Access Compliance Report

Public Rights-of-Way

(Pedestrian Signals)

Intersection ID: N/A	Main Street:	Cross Street: N/A	Location: N/A
ADA ID: 3C91B7BD686B	Signal Type: One Push Button-APS	Overall Compliance: No	Severity Score: BTN 1: N/A BTN 2: N/A No BTN: N/A
Codes/Mitigation Info/Possible Solution		Field Measurements/Component Compliance

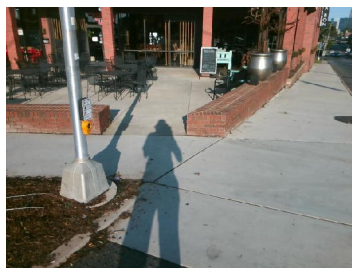
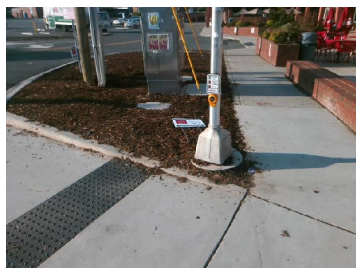
Surveyor Notes: TEXT HT 3/8

PROW/ADA: R410.6, TMUTCD 4e.08, R404.1, R406.2, R404.7.3, R209.1, MUTCD 4e.10

Compliance	Description	Data	Compliance	Description	Data
	Button Count	Button1	N/A	Distant to Additional Button (in)	N/A
	Additional Button Present?	No		Additional Button ID	N/A
N/A	Signal Buttons Required?	N/A	N/A	Additional Ped Posts Required	N/A
	How Many Ped Street Xings?	1		Located In An Island/Median?	No
N/A	B 1 Sign Present?	Yes	N/A	B 2 Sign Present?	N/A
Yes	B 1 Sign Purpose?	Yes	N/A	B 2 Sign Purpose?	N/A
No	B 1 Sign Lettering & Contrast?	No	N/A	B 2 Sign Lettering & Contrast?	N/A
Yes	B 1 Parallel To XWalk?	Yes	N/A	B 2 Parallel To XWalk?	N/A
Yes	B 1 PAR to Button?	Yes	N/A	B 2 PAR to Button?	N/A
Yes	B 1 PAR to XWalk?	Yes	N/A	B 2 PAR to XWalk?	N/A
No	B 1 Clear Floor Space?	No	N/A	B 2 Clear Floor Space?	N/A
N/A	B 1 FWD Approach?	Yes	N/A	B 2 FWD Approach?	N/A
N/A	B 1 FWD Approach Constrained?	No	N/A	B 2 FWD Approach Constrained?	N/A
No	B 1 FWD Approach Reach (in)	14.0	N/A	B 2 FWD Approach Reach (in)	N/A

N/A	B 1 FWD Approach Width (in)	N/A	N/A	B 2 FWD Approach Width (in)	N/A
N/A	B 1 FWD Approach Obstruction?	Yes	N/A	B 2 FWD Approach Obstruction?	N/A
N/A	B 1 FWD Approach Obstruction Dist (in)	9.0	N/A	B 2 FWD Approach ObstructionDist (in)	N/A
N/A	B 1 PARA Approach?	Yes	N/A	B 2 PARA Approach?	N/A
N/A	B 1 PARA Approach Constrained?	No	N/A	B 2 PARA Approach Constrained?	N/A
No	B 1 PARA Approach Reach (in)	14.0	N/A	B 2 PARA Approach Reach (in)	N/A
N/A	B 1 PARA Approach Width (in)	N/A	N/A	B 2 PARA Approach Width (in)	N/A
N/A	B 1 PARA Approach Obstruction?	Yes	N/A	B 2 PARA Approach Obstruction?	N/A
N/A	B 1 PARA Approach Obstruction Dist (in)	9.0	N/A	B 2 PARA Approach ObstructionDist (in)	N/A
N/A	B 1 Clear Floor Space Slope (%)	N/A	N/A	B 2 Clear Floor Space Slope (%)	N/A
N/A	B 1 Clear Floor Space XSlope (%)	N/A	N/A	B 2 Clear Floor Space XSlope (%)	N/A
N/A	B 1 PAR Slope (%)	6.4	N/A	B 2 PAR Slope (%)	N/A
Yes	B 1 Height (in)	30.0	N/A	B 2 Height (in)	N/A

Yes	B 1 Clear Xing Direction?	ClearlyMarked	N/A	B 2 Clear Xing Direction?	N/A
	B 1 Crossing Direction	To E		B 2 Crossing Direction	N/A
Yes	B 1 DistanceTo XWalk (in)	5.0	N/A	B 2 DistanceTo XWalk (in)	N/A
No	B 1 DistanceTo Curb (in)	97.0	N/A	B 2 DistanceTo Curb (in)	N/A
Yes	B 1 Diameter (in)	2.0	N/A	B 2 Diameter (in)	N/A

Is Button 1 APS or Non-APS?	APS	Is Button 2 APS or Non-APS?	N/A
Yes	B 1 VibroTact Arrow?	Yes	N/A
Yes	B 1 VibroTact Parallel to Xing?	Yes	N/A
Yes	B 1 VibroTact Contrast	Yes	N/A
Yes	B 1 Pilot Light?	Yes	N/A
Yes	B 1 Pilot Light Illumination?	Yes	N/A
No	B 1 Verbal Walk Cycle?	Yes	N/A
N/A	B 1 Verbal Message Audible?	Yes	N/A
Yes	B 1 Locator Tone?	Yes	N/A
Yes	B 1 Percussive Walk Cycle?	Yes	N/A
Yes	B 1 Extended Press Feature?	Yes	N/A
Yes	B 1 Tone Audible Range?	Yes	N/A

Possible Solutions: Replace Signal Push Button With APS Button on New Post. Remove & Replace Sign.
